Errata to **DL136/D Rev. 4** **Communications Device Data**

July 19, 1996

This errata applies to the following sections of DL136/D, Rev. 4, Q1/96:

Block Diagram of 70 MHz Video Receiver Application Circuit

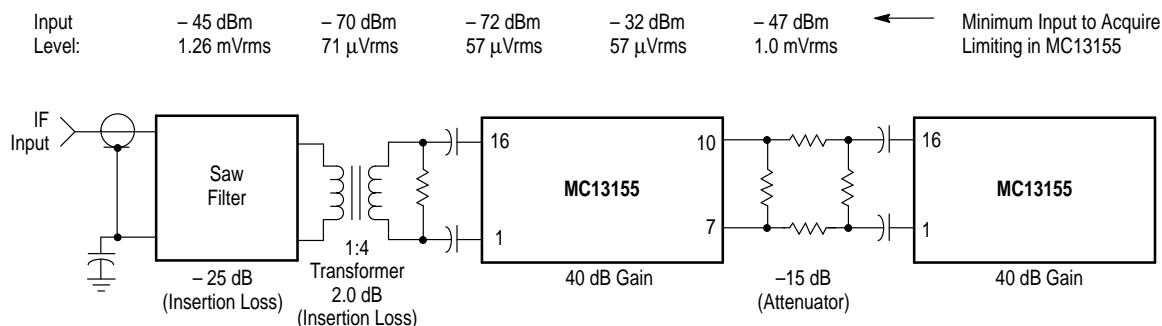
2-186 The Block Diagram should appear as follows:

PIN ASSIGNMENTS

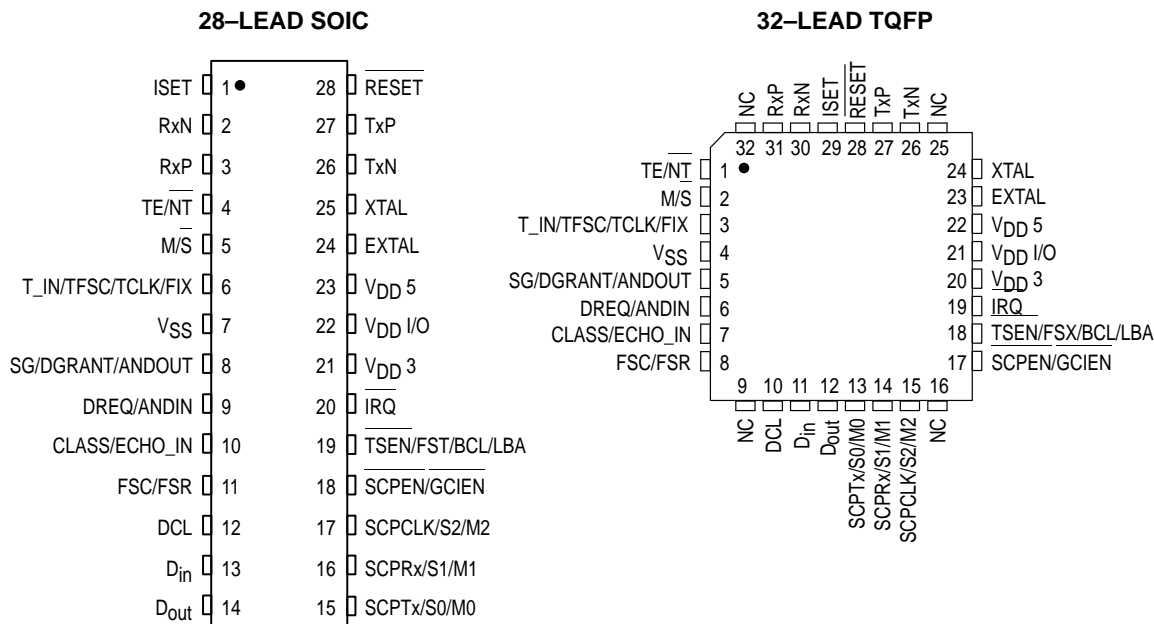
2–1196 The pin assignments should be changed to the following:

Package Dimension 873A-02

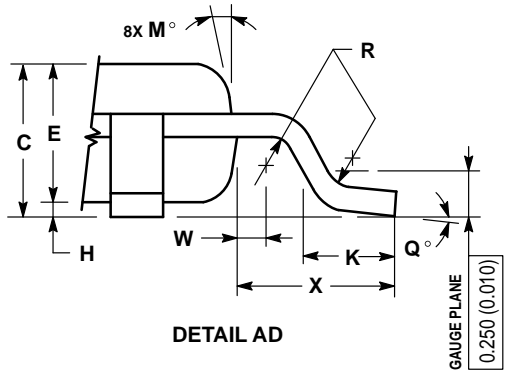
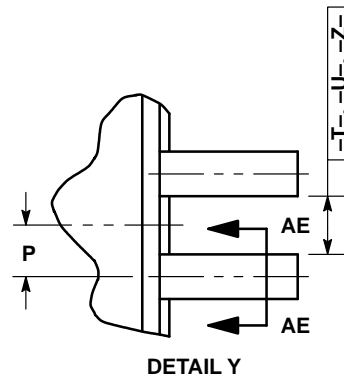
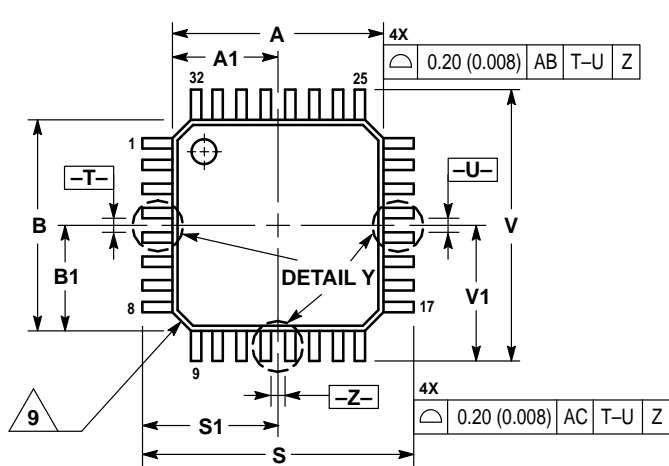
8-12 The package dimension for Case 873A-02 (PB Suffix) should be added to the mechanical section. This corresponds with MC145574, ISDN S/T Interface. The package is as follows:

Package Dimension 940C-02

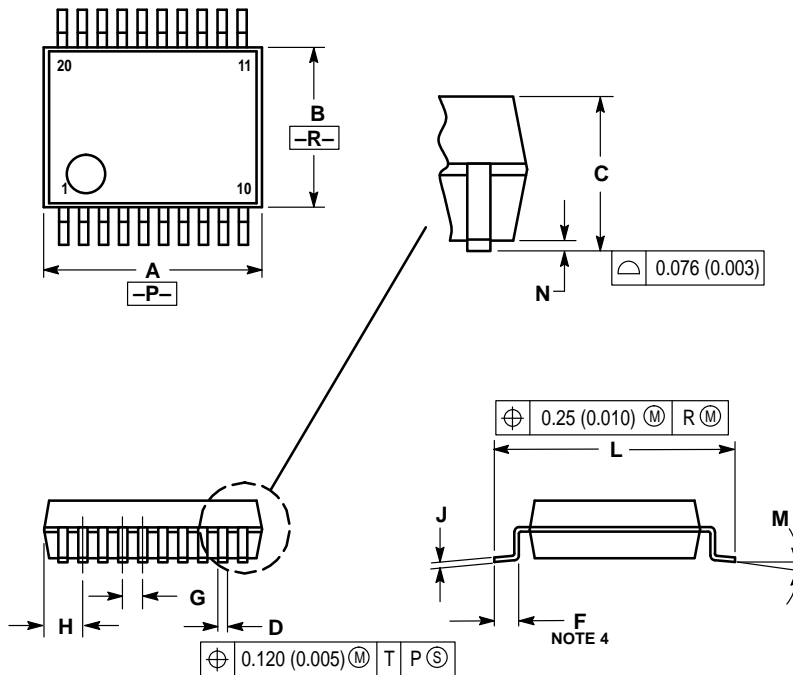
The package dimension for Case 940C-02 (SD Suffix) should be added to the mechanical section. This does **not** replace Case 940C-03 (VF Suffix). The package is as follows:
